AGENDA
February 17, 2015
Town Hall BOS Meeting Room - 6:30 PM

Date: February 17, 2015
To: Town of Milford Planning Board
From: Jodie Levandowski, Town Planner
Subject: James E. & Charles P. Saytanides/John K. & Catheryn A. Philbrick – Federal Hill Rd – Map 56, Lots 54 & 56: Public Hearing for a lot line revision and subdivision creating one (1) new residential lot.

The Milford Planning Department has requested Comprehensive Environmental Inc (CEI) to review the traffic study, roadway design, drainage design and supporting drainage calculations as depicted in the design plans and associated documentation for the proposed consolidation and open space subdivision of tax map 45 lots 3, -17 & -18 and map 40 lot 104-4 in Milford, NH. This letter summarizes CEI's comments on traffic, roadway and subdivision design in accordance with the Milford Development Regulations, and DPW Infrastructure Design, Construction and Administration Standards and the management of stormwater in compliance with the Milford Stormwater Management and Erosion Control Regulations.

LOT LINE REVISION & SUBDIVISION PLAN
LANDS OF:
JAMES E. & CHARLES P. SAYTANIDES
AND JOHN K. & CATHERINE A. PHILBRICK REV. TRUST OF 2005
FEDERAL HILL ROAD
TAX MAP 56 LOTS 54 & 56
MILFORD, NEW HAMPSHIRE
 SCALE: 1" = 80' JANUARY 15, 2015

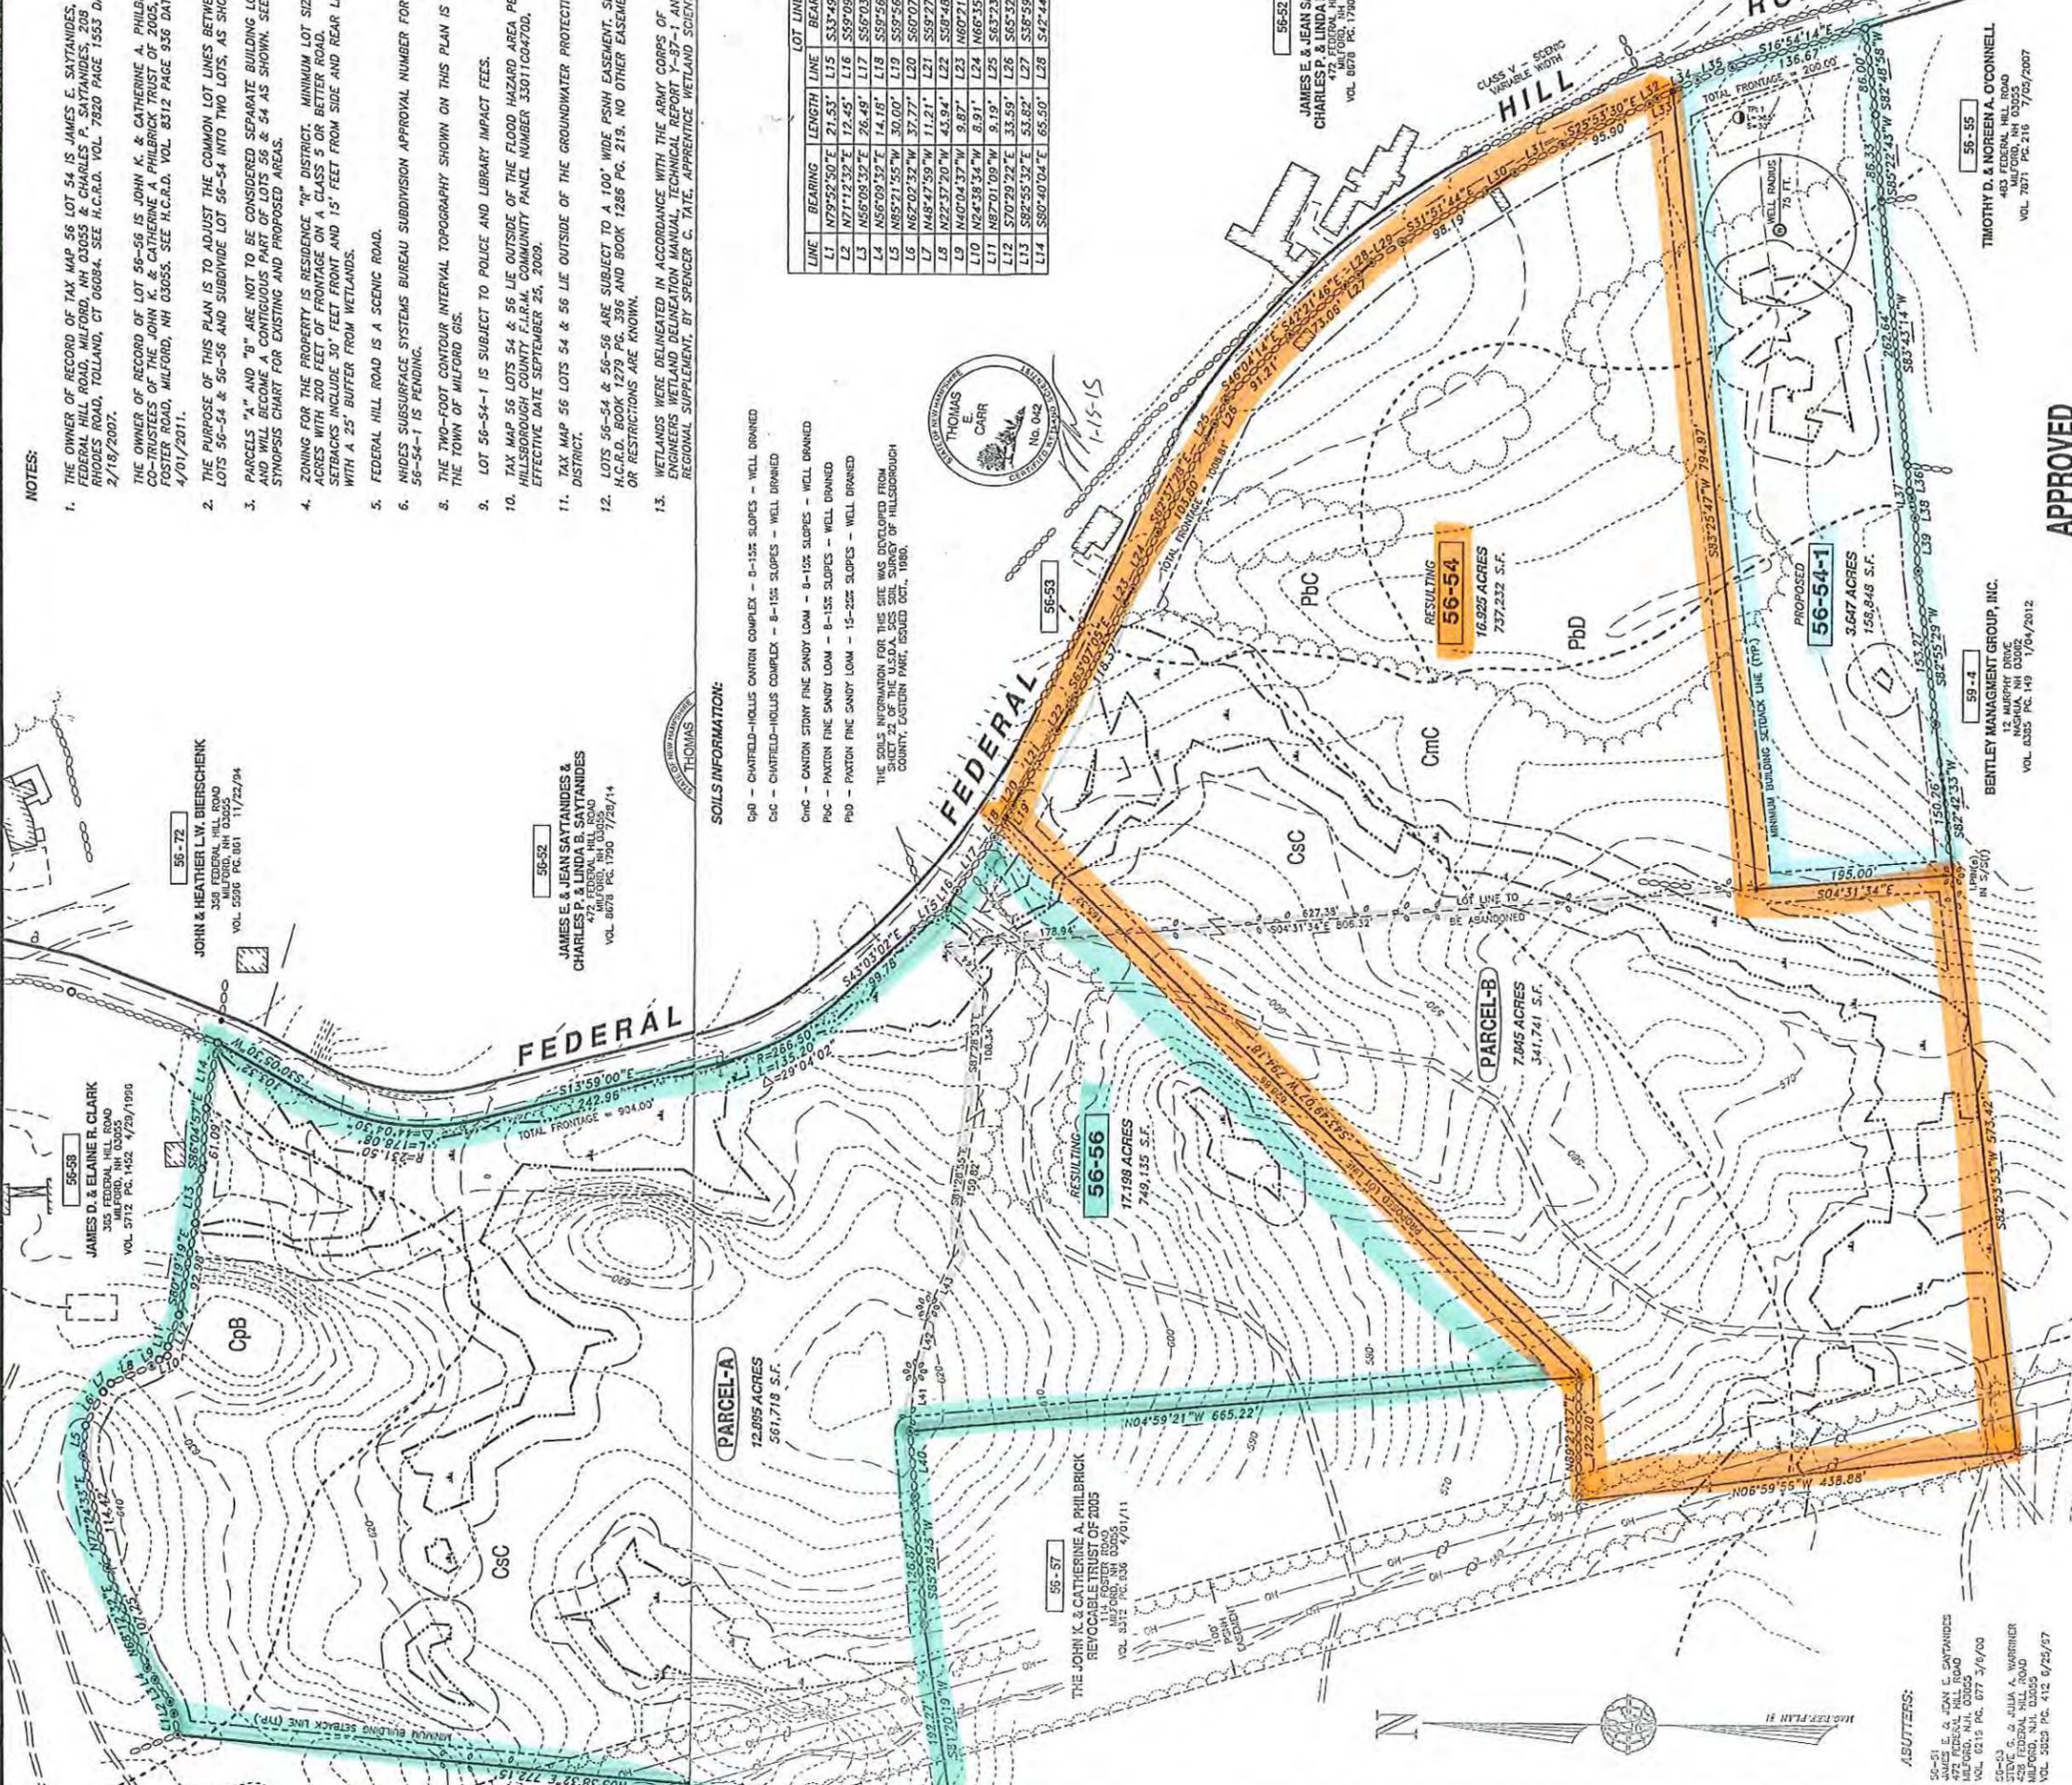
Staff has no significant issues with the plan as presented. It is the recommendation of staff that the Planning Board grant minor subdivision approval, subject to the following administrative conditions:

1. A letter from a licensed surveyor be submitted to the Building Department attesting that all lot monumentation has been set prior to final Planning Board approval or a security be put in place for all property bounds and submitted to the Office of Community Development;
2. Existing and proposed lot areas be added to the plan notes;
3. All state permit approval numbers and expiration dates be added to the notes section as necessary;
4. A note be added stating lot 56-54-1 shall require Stormwater Management Permit approval prior to issuance of a building permit.

LOT LINE ADJUSTMENT
PLAN OF LAND
LOT 49-2
CASEY LIVING TRUST
LOT 49-3-7
BRET P. JEPSON
MAUREEN B. JEPSON
LOT 49-3-18
THE PAUL & JANICE
BARTOLOMUCCI
REVOCABLE TRUST
MILFORD, NEW HAMPSHIRE

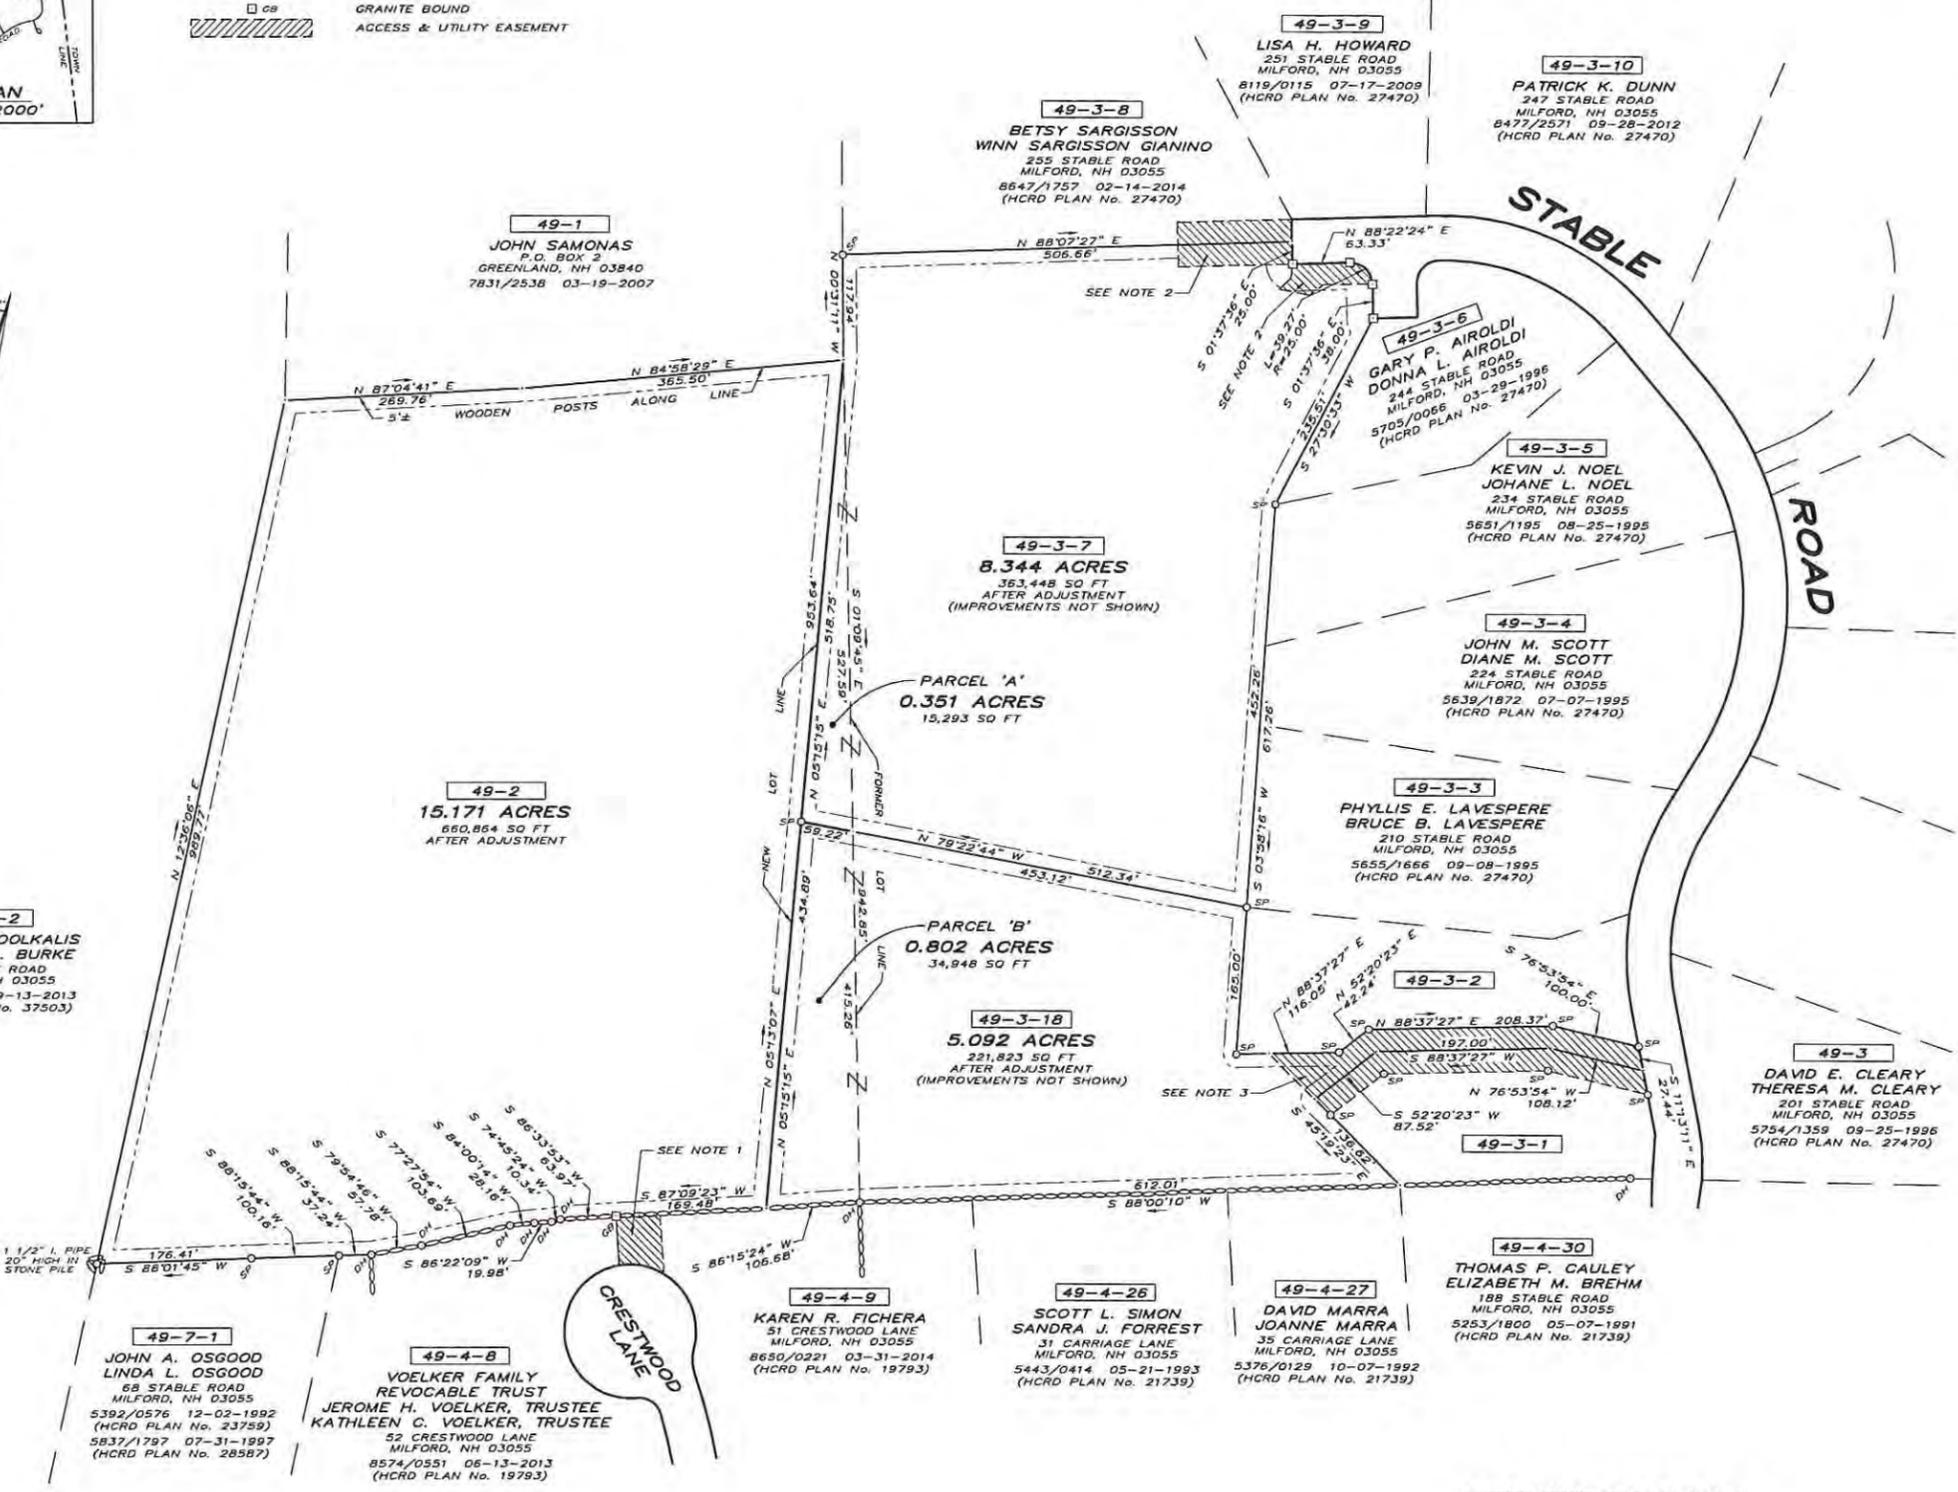
Zoning Administrator: I would recommend approval of the waiver request from submittal requirements for Map 49/Lot 2, Map 49/Lot 3-7, and Map 49/Lot3-18 as it is not necessary to accomplish the proposed lot line adjustment and many recorded plans are on file from previous surveys of either parcels or adjacent parcels.

The Board should determine whether the waiver request meets the requirements stated in 5.020 on the Development Regulations for granting a waiver. Following discussion and a determination on the waiver the Board should make a motion on the request. Staff supports the request for a waiver from the submittal requirements as it is not necessary to accomplish the proposed lot line adjustment and many record plans are on file from previous subdivisions and surveys of the subject properties or adjacent parcels in this area.

Staff has no significant issues with the plan as presented. It is the recommendation of staff that the Planning Board grant minor subdivision approval, subject to the following administrative conditions:
